# Recall Bulletin

## PRODUCT SAFETY RECALL

**SUBJECT:** Compressed Natural Gas (CNG) Fuel Tank Shut-Off Solenoid Connector

**MODELS:** 2011-2013 Chevrolet Express  
2011-2013 GMC Savana  
Equipped with CNG Fuel System

3457040

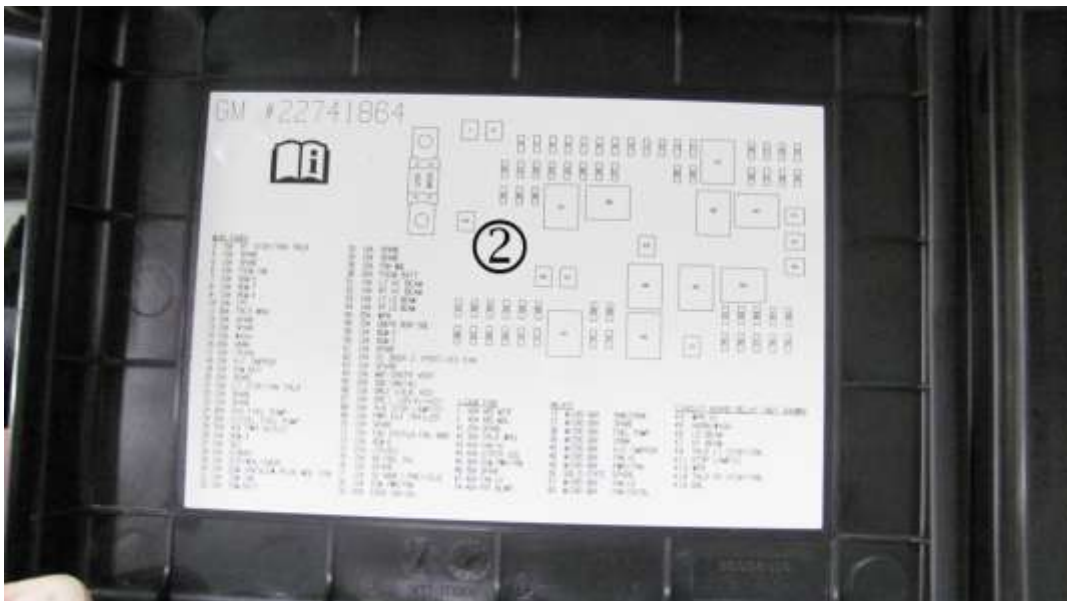
3. Locate the 30-amp fuel pump fuse and remove it from the underhood electrical center or junction block (1). Refer to number 24 on the fuse and relay label, which is located on the underside of the underhood electrical center cover.
4. Discard the 30 amp fuel pump fuse.

- If the vehicle is equipped with a 4-tank system (RPO UFP), install a 7.5-amp fuse.
- If the vehicle is equipped with a 3-tank system (RPO UFM), install a 5-amp fuse.

3457063

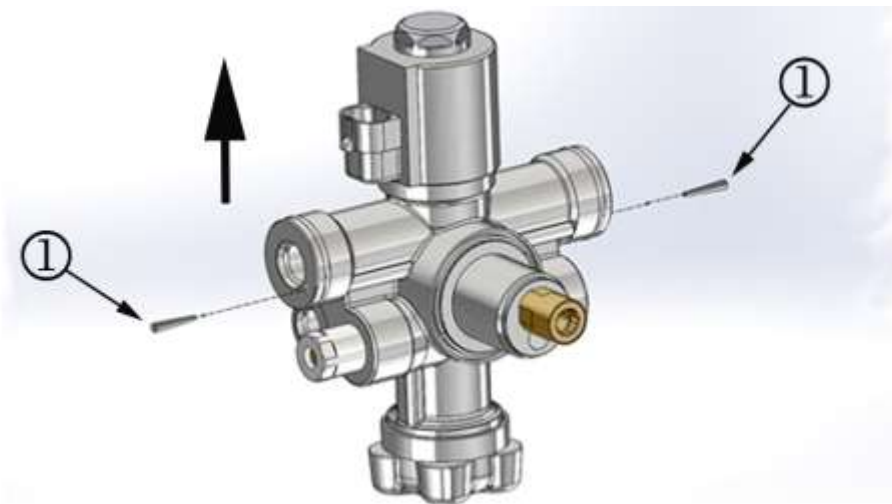
Electrical connector harness shown with no strain on the harness. Note that there is slack in the harness. If the harness does not have any slack, remove the tie strap and adjust the harness. Secure the harness with a new tie strap.

14. Verify that there is no strain on HPL solenoid electrical connector.

- If there is strain on the electrical connector harness, remove the connector tie strap and reposition the harness to relieve the wire strain. Install a new tie strap to secure harness.
- If there is no strain on the electrical connector harness, proceed to step 15.

3530550

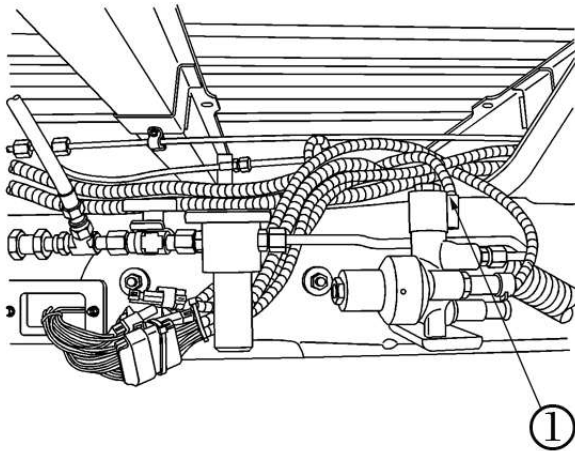
**Connector must point upward.**

15. Install two CNG cylinder tank valve plugs (1). Refer to the illustration. This step can be skipped for 2013 model year vehicles, which have plugs already installed.

3530545

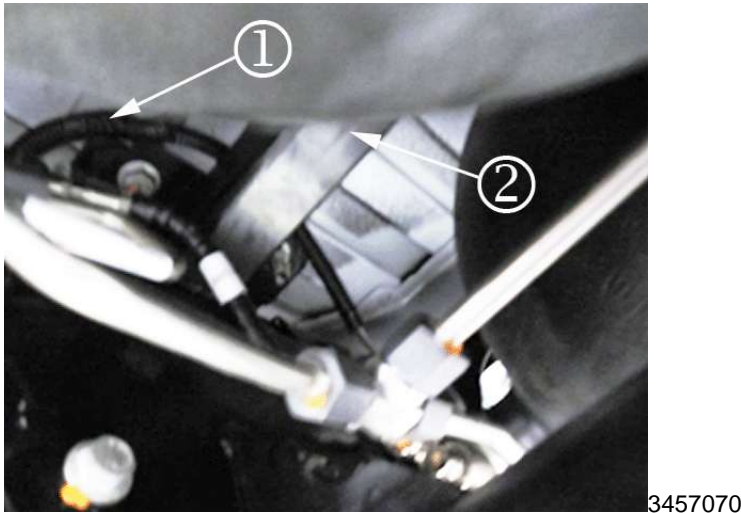
8. Replace lower HPL solenoid coil seal (1).
9. Using the reference mark created in step 4, install a new HPL solenoid coil on the aft assembly. Turn the forward coil 180 degrees to face the aft tank assembly.

**Note:** Both HPL solenoid connectors should face each other after installation.

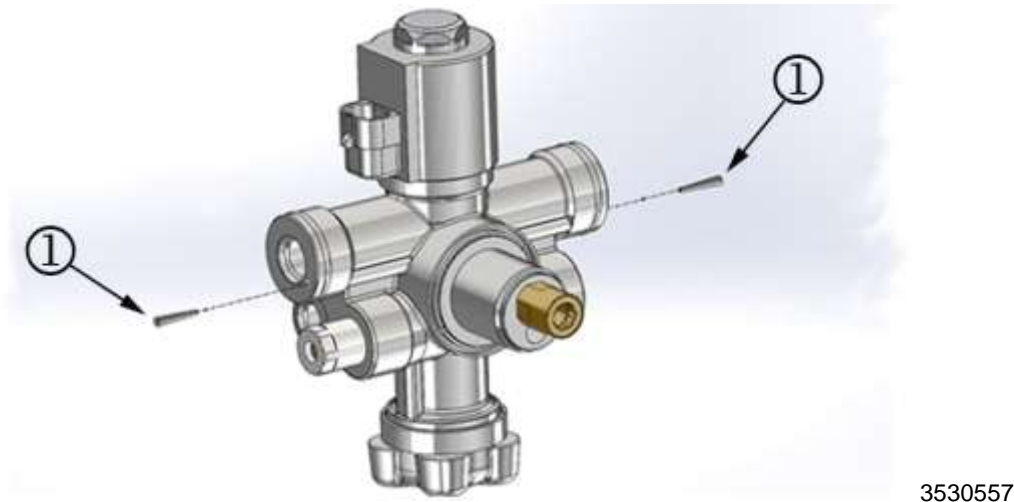
14. Route the forward HPL solenoid harness (1) over the top of brace (2) so that the connector feeds directly into the solenoid.
15. Connect the HPL solenoid harness connector.
